Subject: Submission of the Permit Modification Request for Updated Closeout/Closure Plan Schedule, Updated PMLU and Disposal Cell Expansion, Permit CI002RE, Rev. 13-2; Mt. Taylor Mine

**Rationale for the Updated
Closeout/Closure Plan Schedule,
Conceptual Design of the Expanded
Disposal Cell Plan and Updated
PMLU, Mt Taylor Mine**

5/15/2020

SIZE: **B** SCALE: AS SHOWN
FIGURE 1

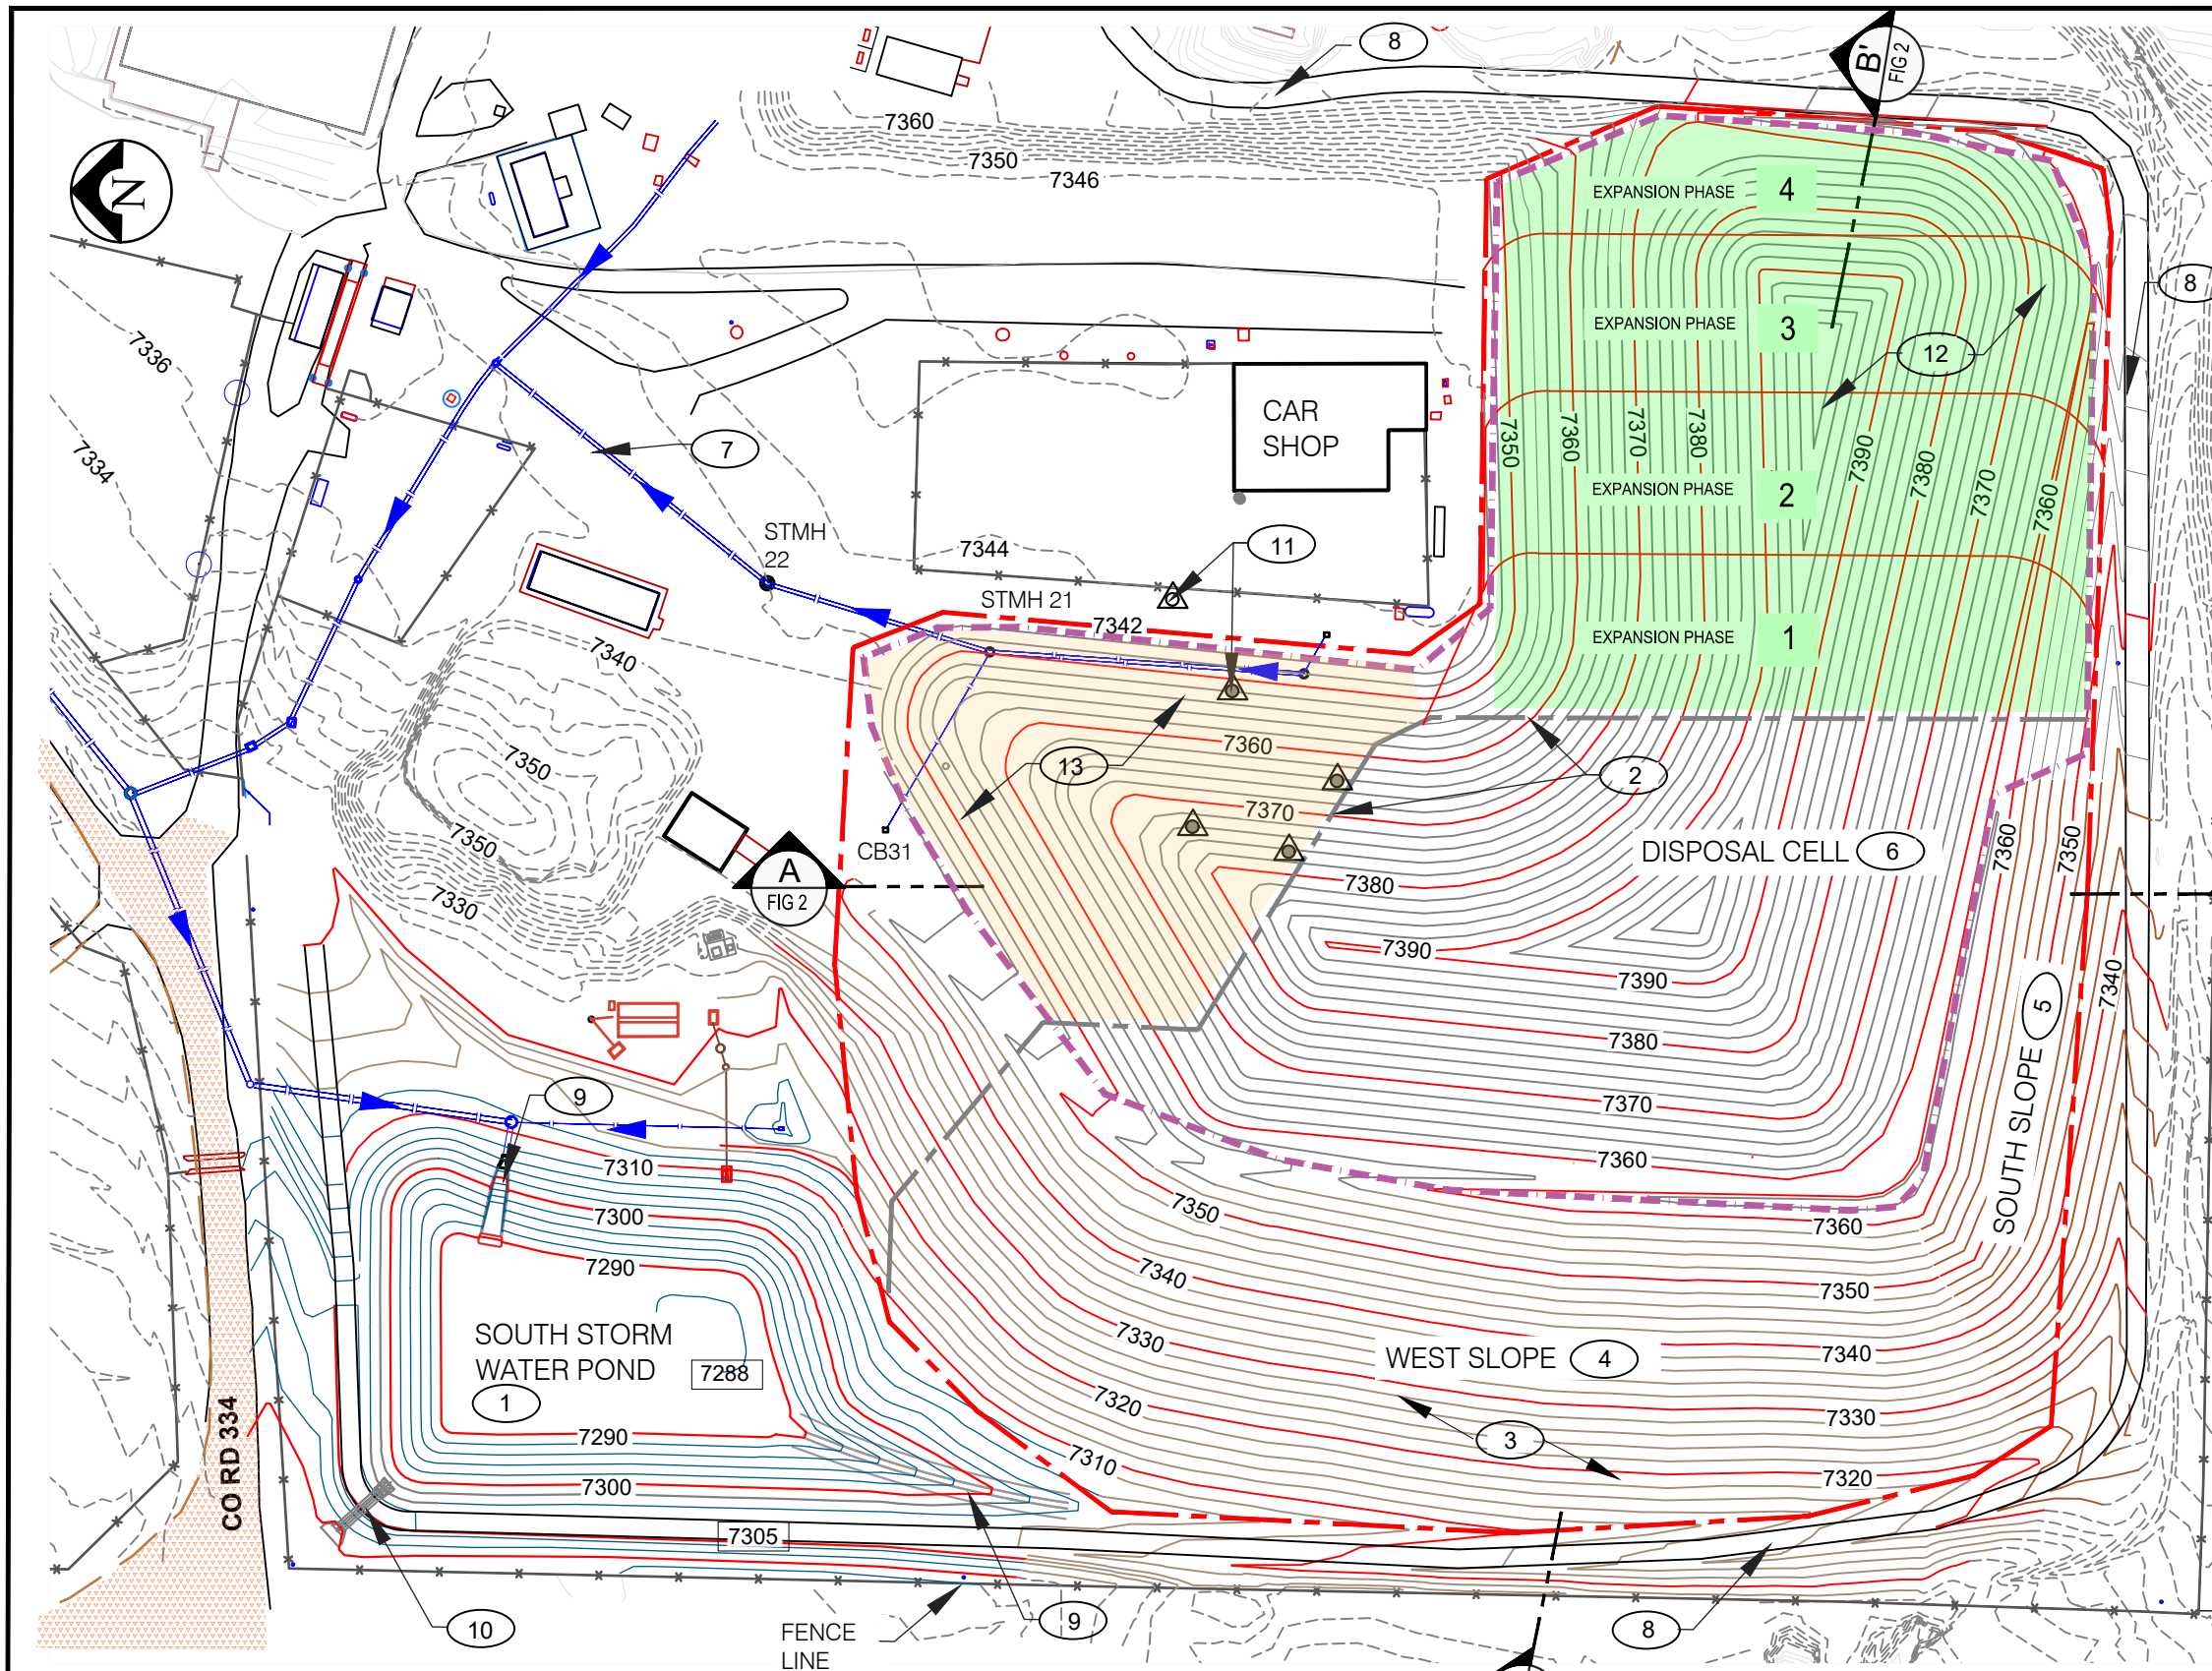
Figures 1 and 2 show RGR's conceptual design for the expanded disposal cell. In this design concept, the existing disposal cell will be expanded eastward in stages. Four stages are contemplated, with floor liner and berms being constructed sequentially based on the amount of contaminated materials identified at the time. RGR does not expect to construct the cell to full build-out unless the volume of contaminated materials discovered during the CCP implementation requires it. Slopes will be maintained at a 5:1 (H:V) configuration. The construction will be according to the previously approved design specifications in the 2013 CCP and earthwork specifications for the Phase I construction.

- 1 SOUTH STORM WATER POND WITH 2' THICK CLAY LINER
- 2 WASTE ROCK PILE AND DISPOSAL CELL AS OF DECEMBER 2019 - (11.5 ACRES)
- 3 WASTE ROCK PILE SLOPES = 5H TO 1V
- 4 WEST SLOPE = WASTE ROCK WITH 2' RADON BARRIER COVER SOILS.
- 5 SOUTH SLOPE = CONSTRUCTED WITH CLEAN SOILS
- 6 DISPOSAL CELL WITH 1' THICK CLAY LINER
- 7 STORM DRAINAGE PIPES, MANHOLES
- 8 SERVICE ROADS
- 9 CONCRETE CHUTE
- 10 OVERFLOW PIPES = 2 -24" DIA.CMP PIPES
- 11 LAGOON DEWATERING WELLS.
- 12 PROPOSED EXPANSION AREA (PHASES 1 - 4)
- 13 FILL OVER LAGOON AREA ONLY IF NEEDED (PHASE 5).

RIO GRANDE RESOURCES CORP. MOUNT TAYLOR MINE - San Mateo, NM		PROJECT TITLE: MT. TAYLOR MINE CLOSEOUT/CLOSURE PLAN	
		SHEET TITLE: PROPOSED EXPANSION OF WASTE ROCK PILE AND DISPOSAL CELL SECTIONS	
Prepared By: Alan Kuhn Associates LLC	SIZE B	SCALE: AS SHOWN Figure 2

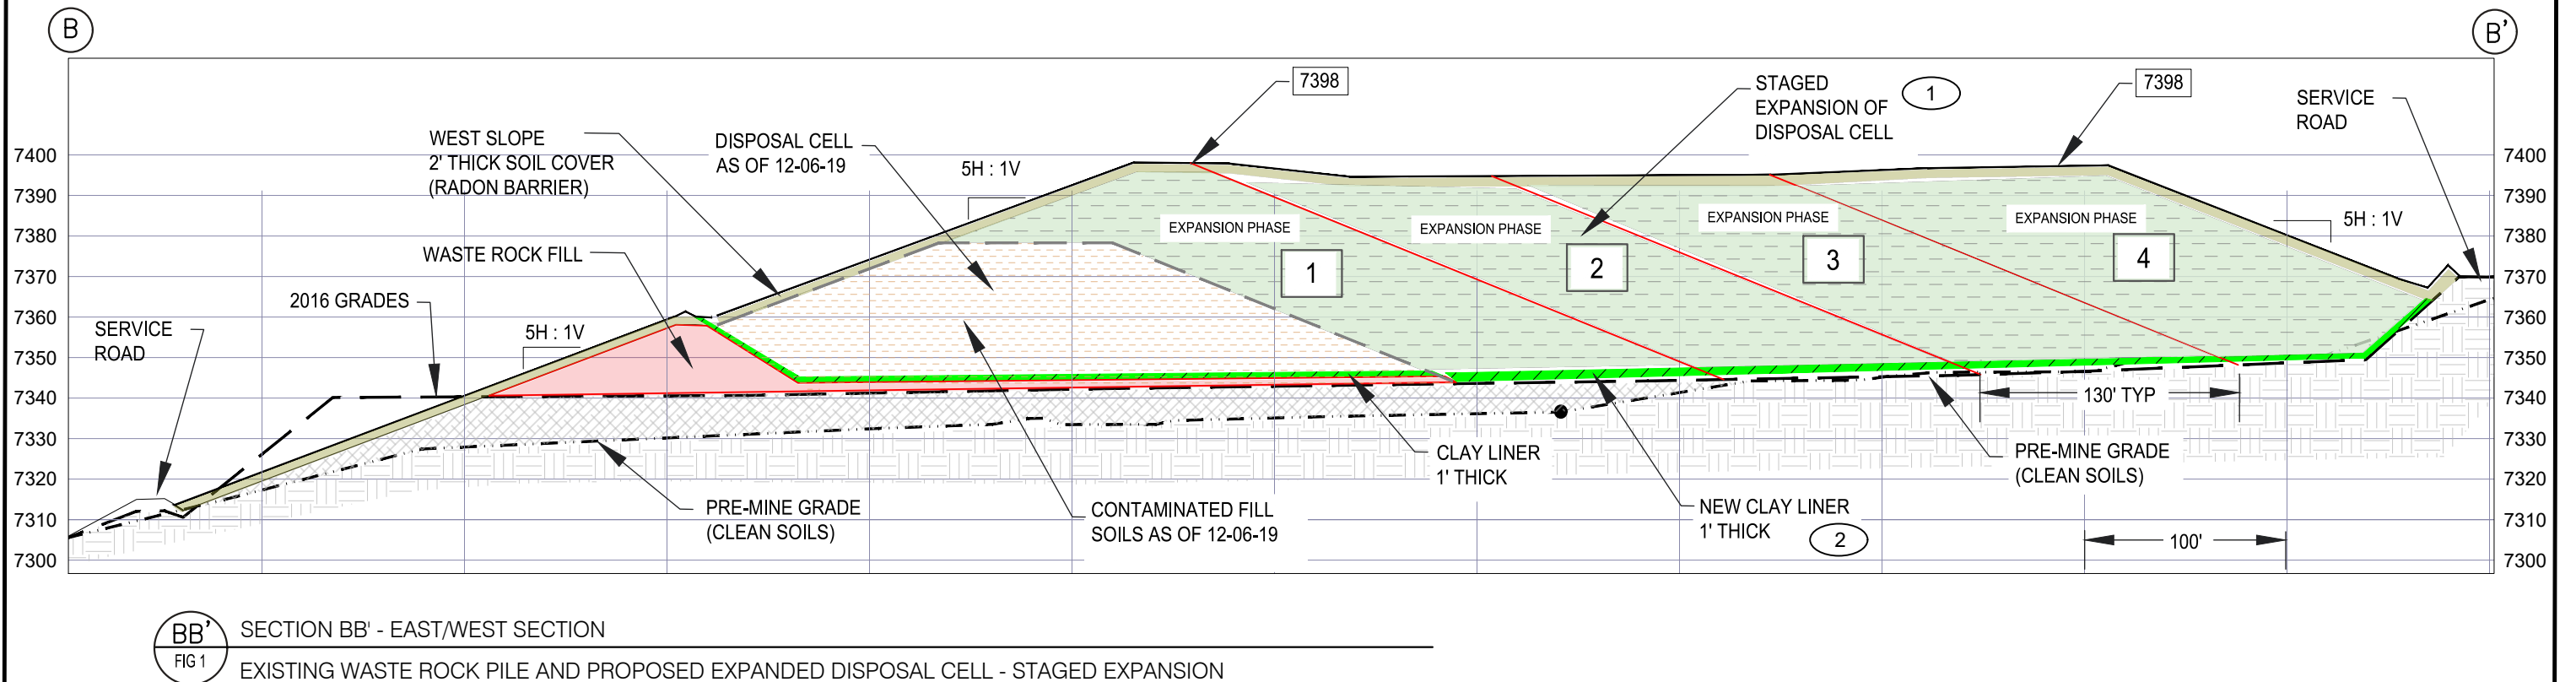
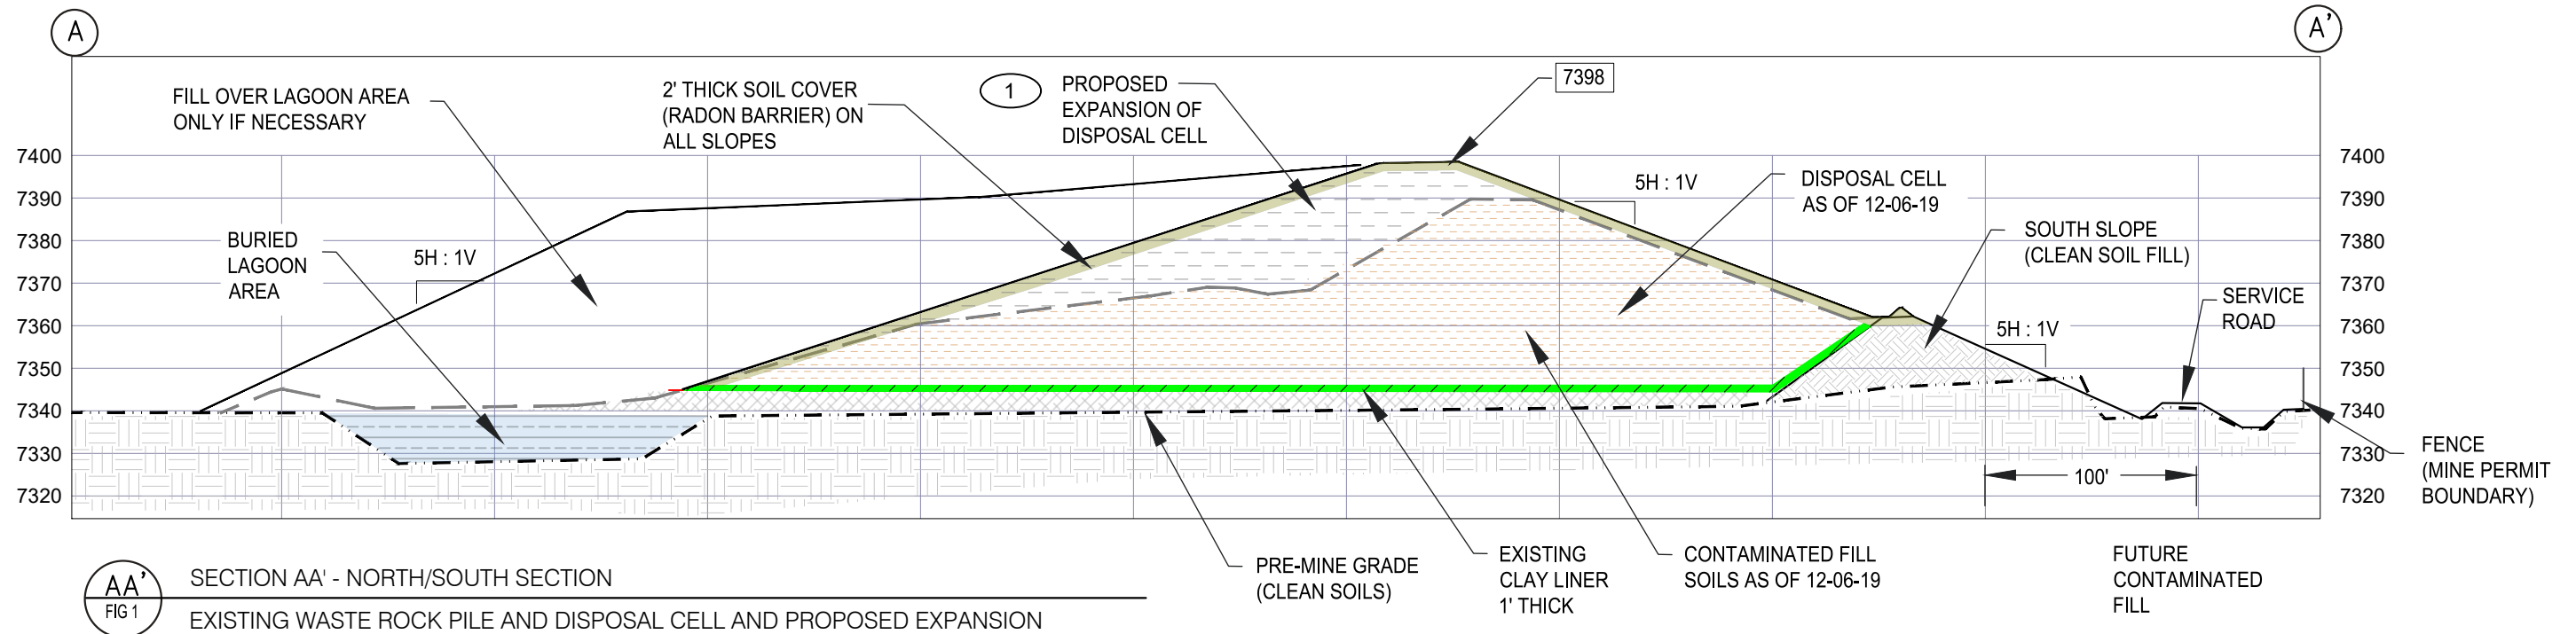
- ① PROPOSED EXPANDED SHAPE (SIZE AND HEIGHT) OF THE DISPOSAL CELL WILL VARY DEPENDING ON THE AMOUNT OF CONTAMINATED SOIL EXCAVATED FROM THE CLEANUP OF THE SITE.
- ② THE NEW CLAY LINER TO EXTEND ONLY AS MUCH AS NEEDED TO ACCOMMODATE THE AMOUNT OF CONTAMINATED SOIL EXCAVATED FROM THE SITE.
